Project: Specifications for UNC MEMORIAL HALL
114 E CAMERON AVE
CHAPEL HILL, NORTH CAROLINA 27514
ROOF REPLACEMENT PROJECT
SCO ID NO. 22-25151-01A

Project No. FJ226041

Date: February 28, 2024

ADDENDUM NO. 1

PRELIMINARY STAGING PLAN

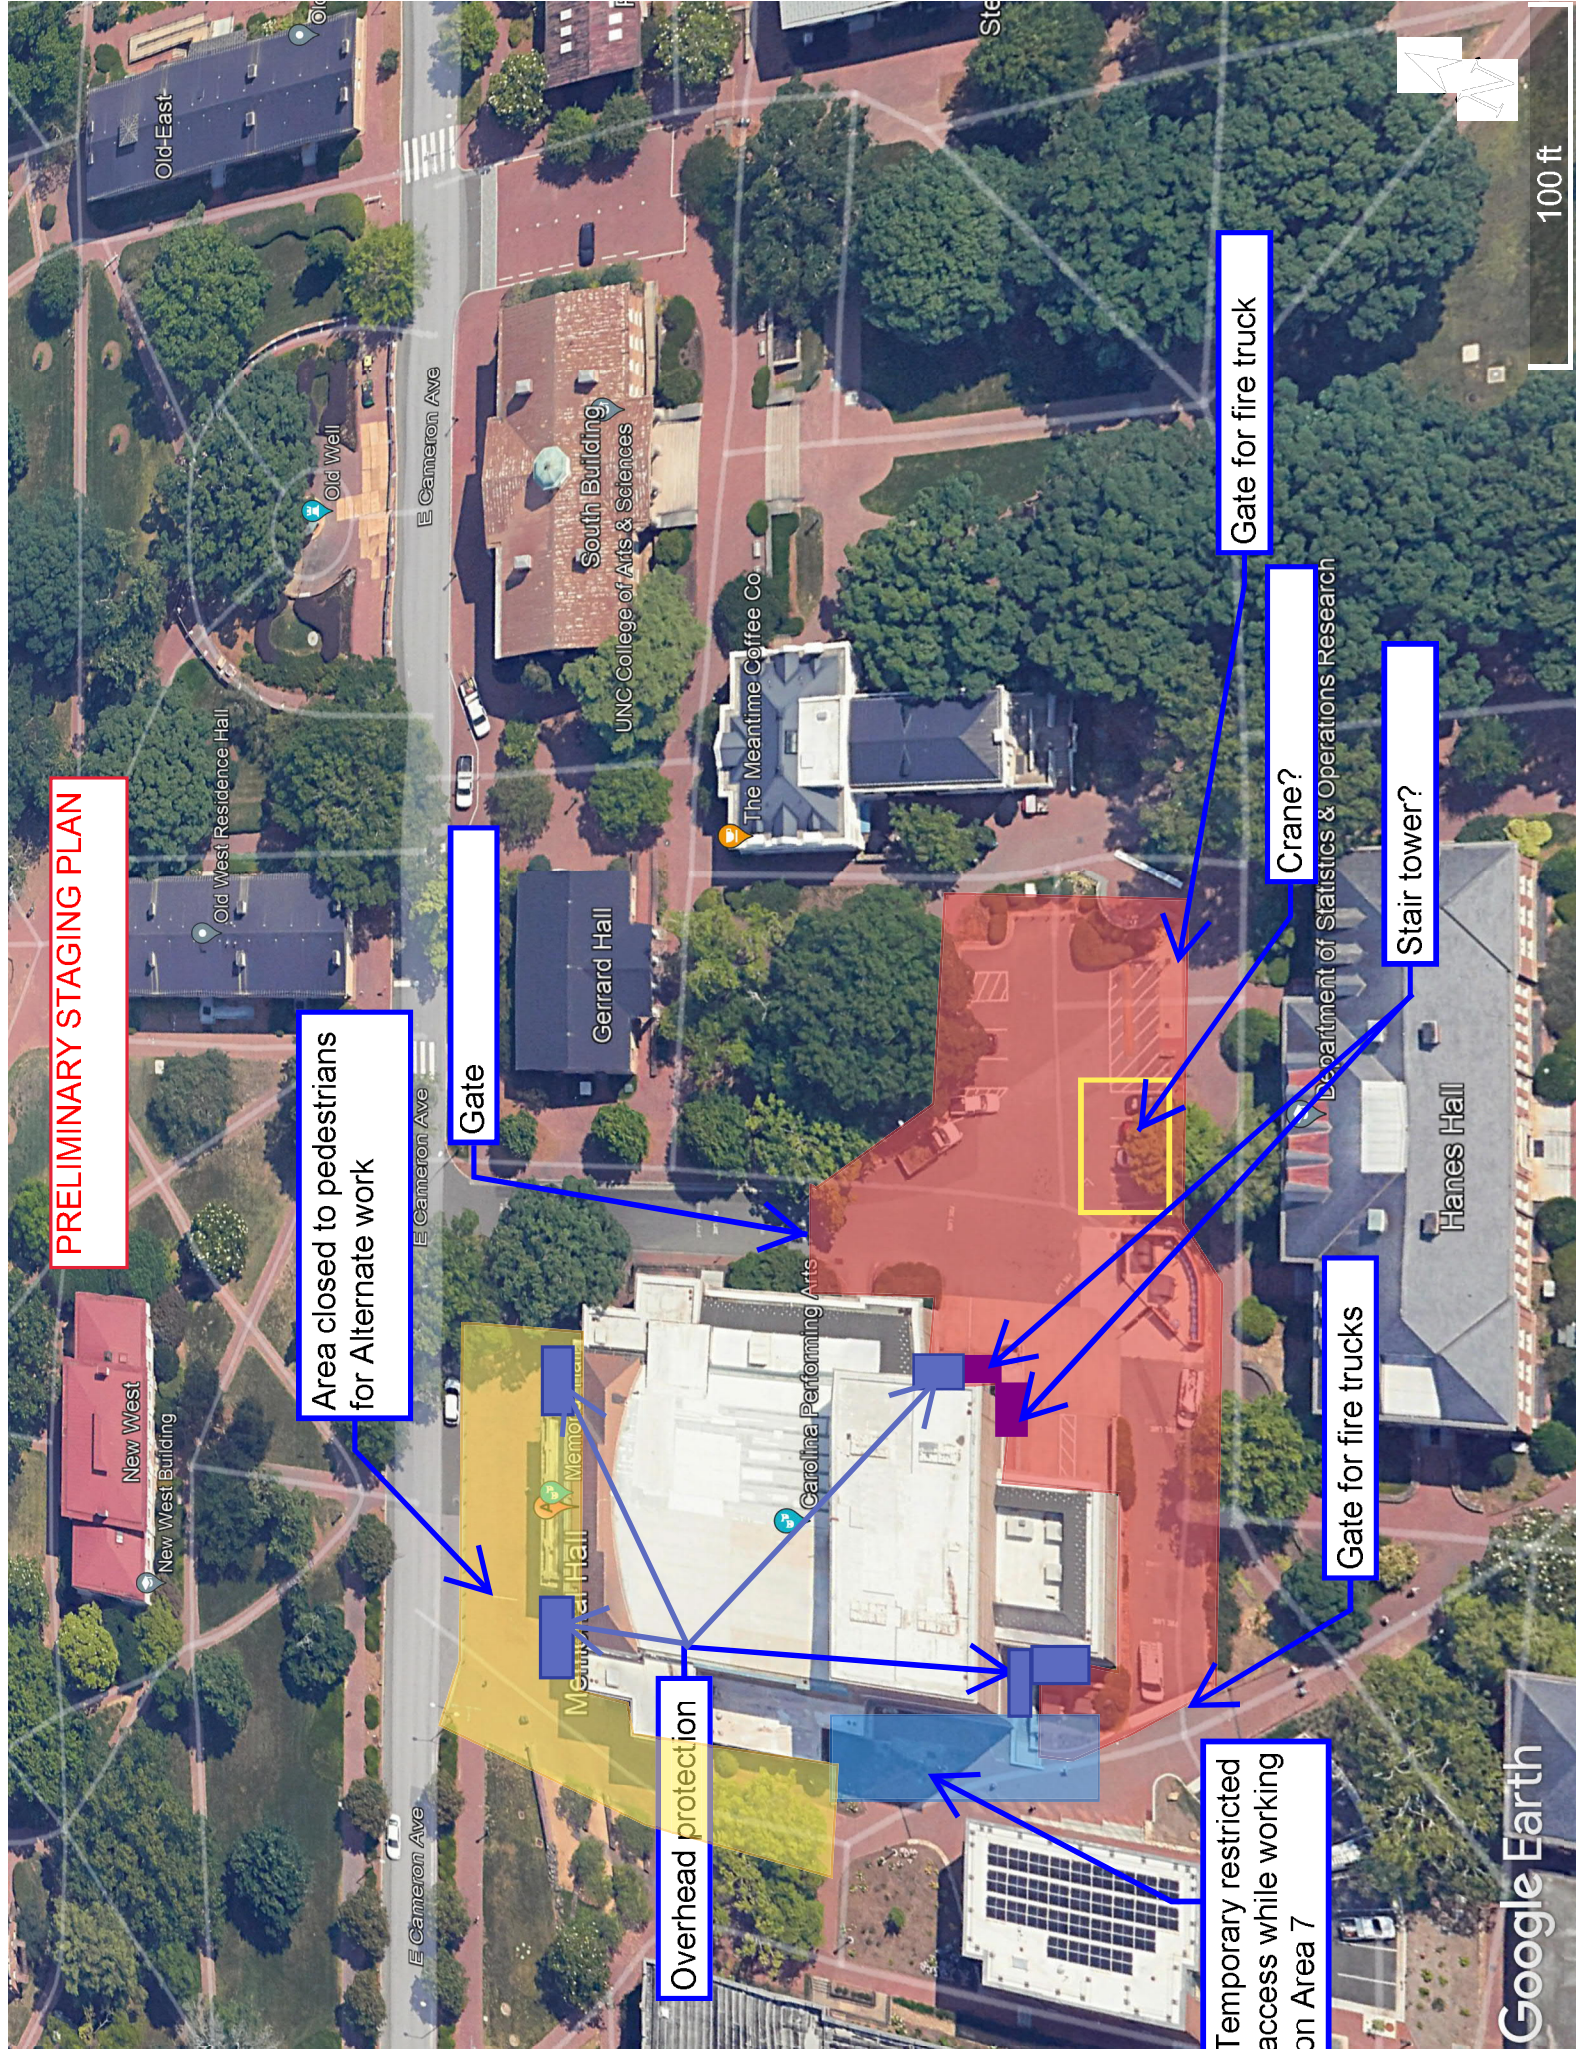
1. Refer to attached "PRELIMINARY STAGING PLAN" aerial image.
2. The Pre-bid meeting minutes are hereby incorporated into this Addendum.

Area closed to pedestrians for Alternate work

Temporary restricted access while working on Area 7

Gate for fire truck

Gate for fire trucks
